## Landmarks Preservation Commission Community & Economic Development Department

Date: October 26, 2011  
 Location: 747 Market St, Tacoma Municipal Building, Room 248  
 Time: 5:00 p.m.

**STAFF REPORT**

**AGENDA ITEM 3B: 1401 N 5<sup>th</sup> Street (North Slope Historic Special Review District)**

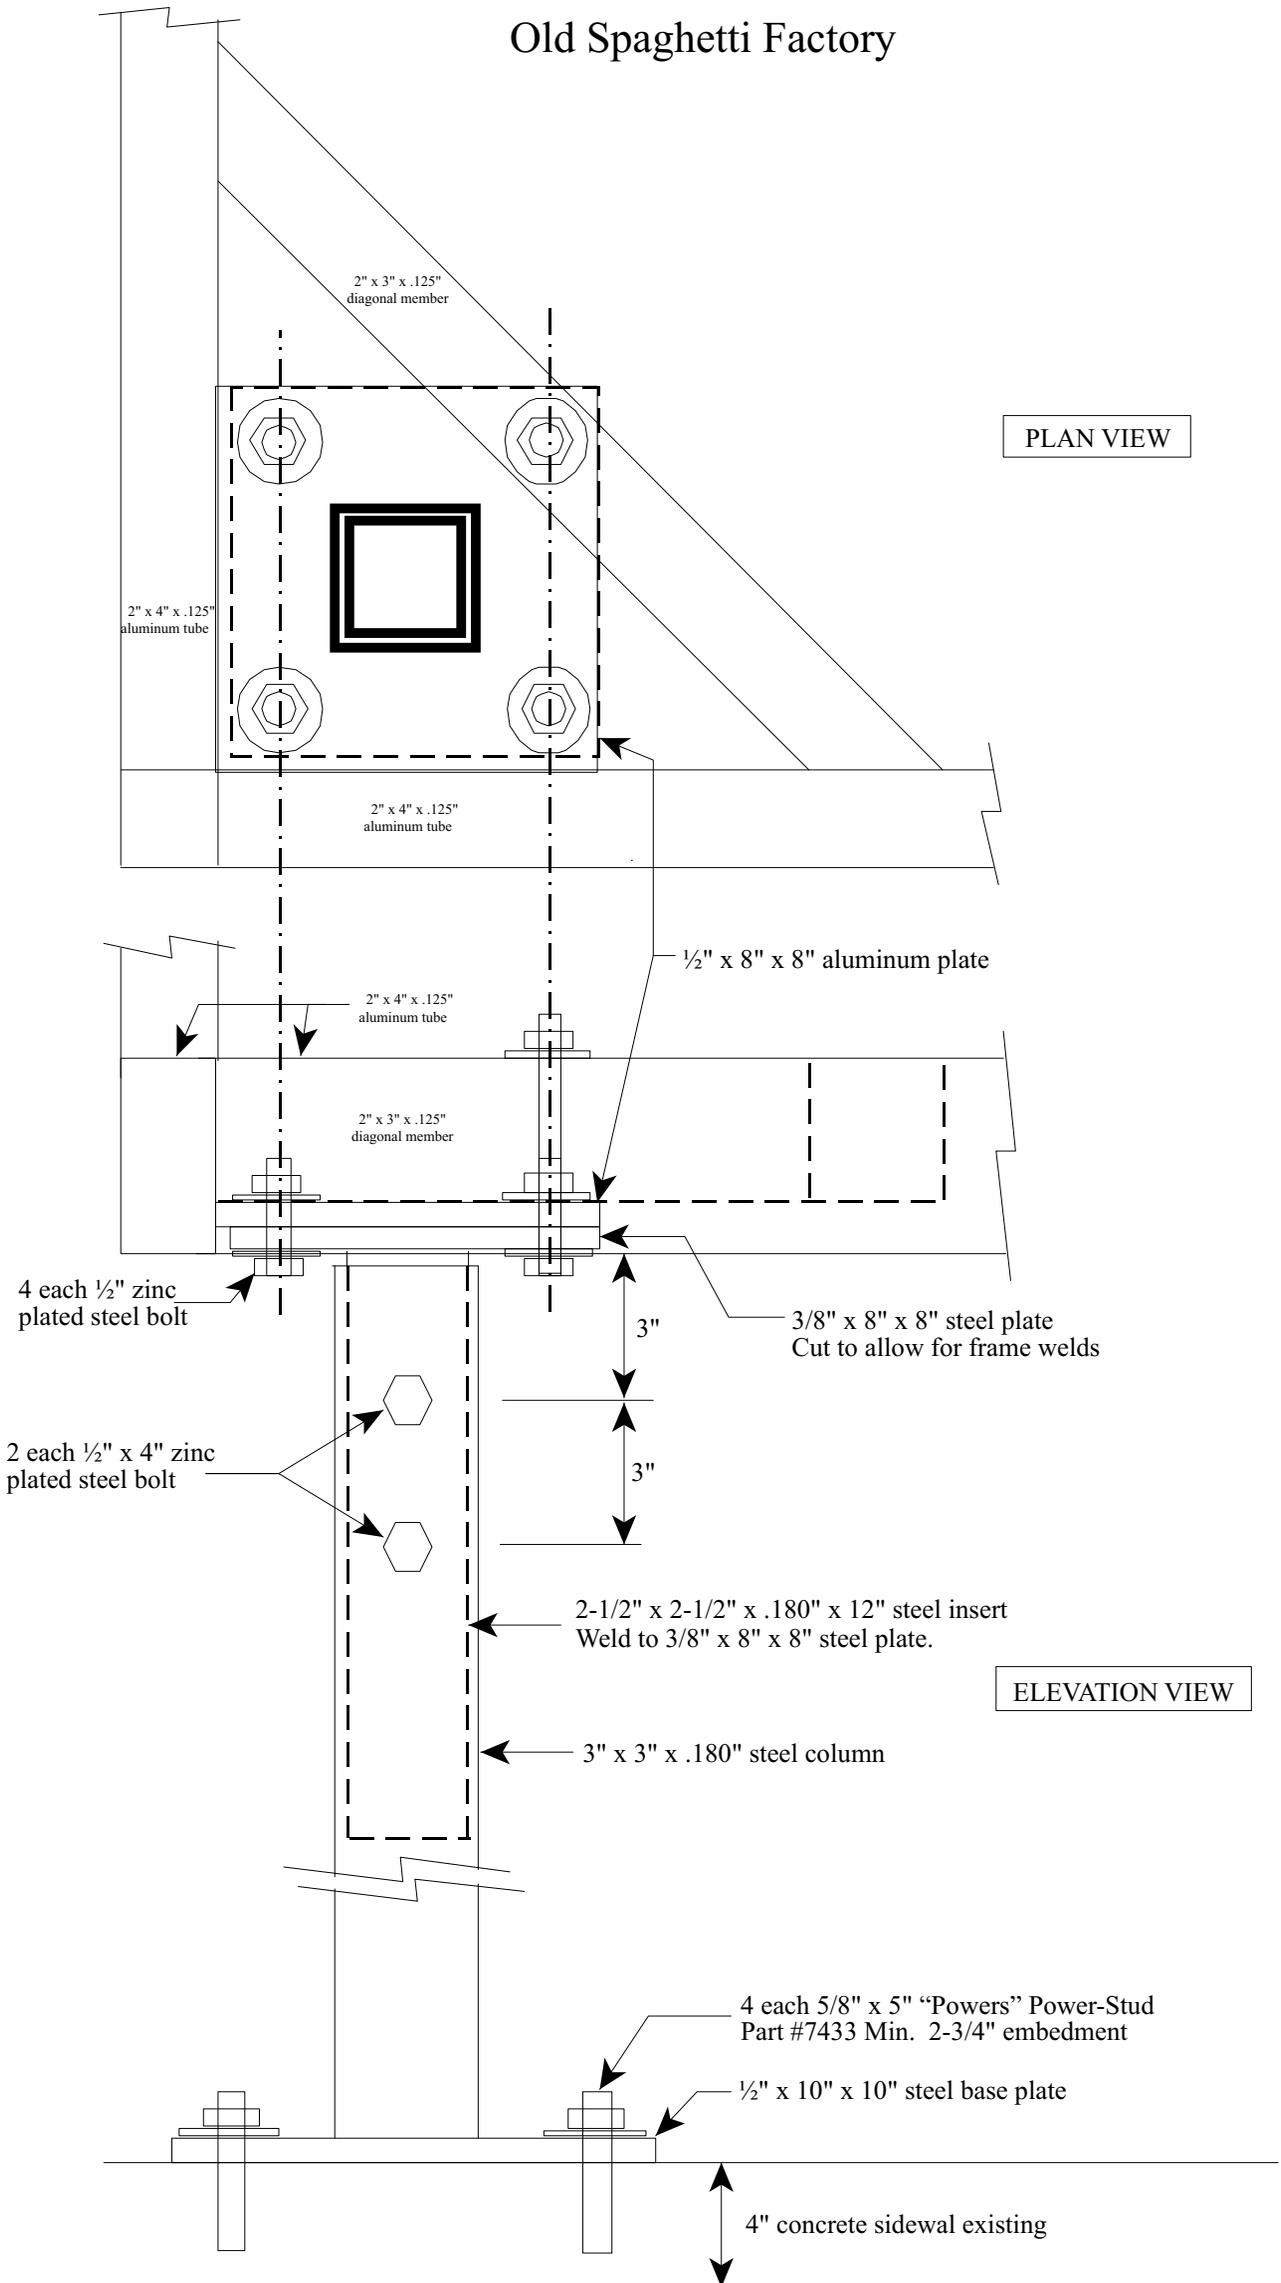
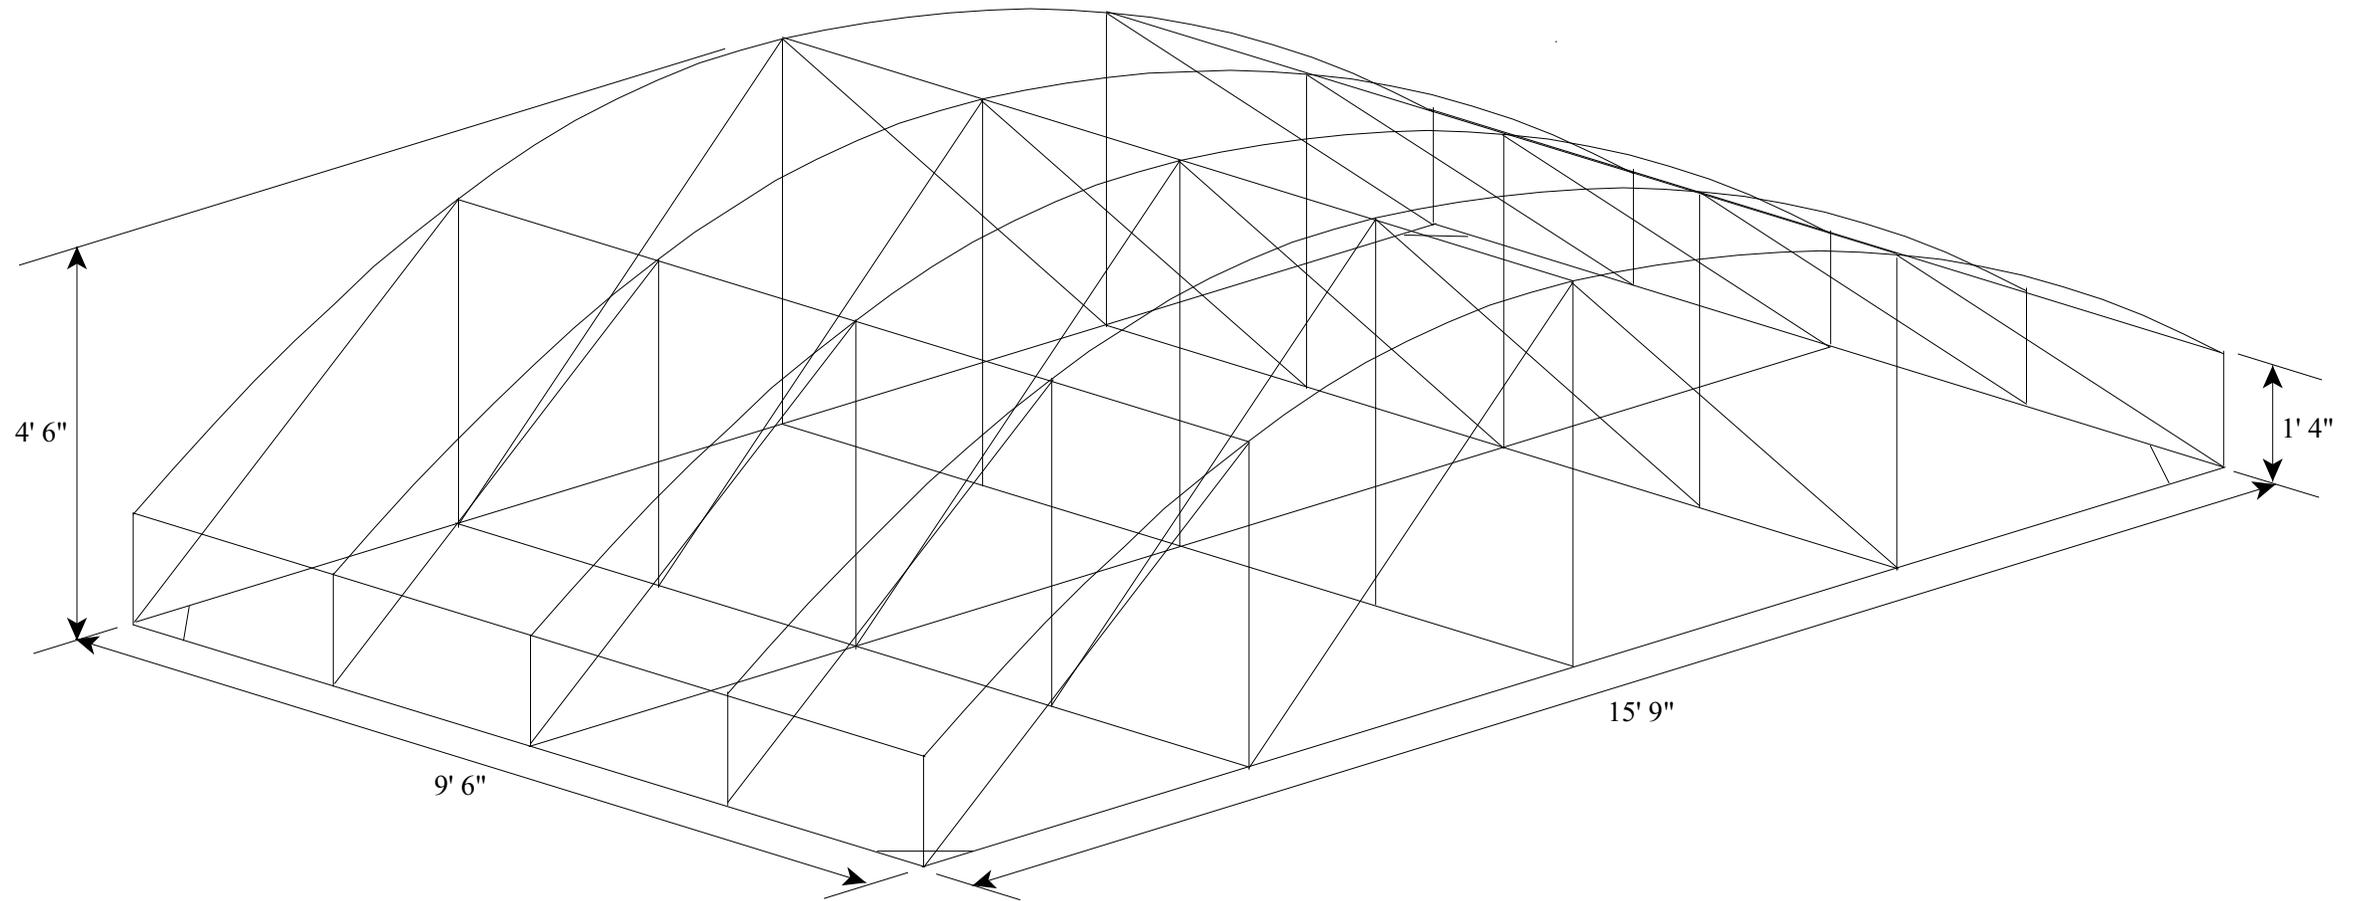
5. The proposed new entry canopy is a new design and will project an additional 4’6” over the sidewalk area.
6. The proposed new design of the canopy appears to nearly enclose the window area, which may meet *Union Depot-Warehouse Historic District* Guideline #6, Awnings, a. specifically, to “Reflect the shape and character of the window openings...”

8. The proposed attachment method appears to use the existing canopy’s holes for attachment, thus, not increasing the number of holes in the building, thus the awning/canopy meets *Union Depot-Warehouse Historic District* Guideline #6, Awnings, f., “Be attached to the buildings in a manner which does not permanently damage the structure or obscure significant architectural features”. The awning/canopy covers the holes and does not damage the building further with additional penetrations, pending confirmation by the applicant at the meeting. The column posts will be attached in the sidewalk area.

9. The proposed logo sign on the canopy appears to match the existing logo sign and meets *Union Depot-Warehouse Historic District* Guideline #7. Signs, c, (1), specifically for, “The use of pictorial symbols or logos is encouraged” and, d. Color (1) *Light-colored letters on a dark-colored background are generally required as being more traditional and visually less intrusive in the context of the Union Station District’s predominantly red-brick streetscapes*. The logo letters are a light color on a black background.

Staff recommends adopting the above as findings and approval of the project by the Commission.
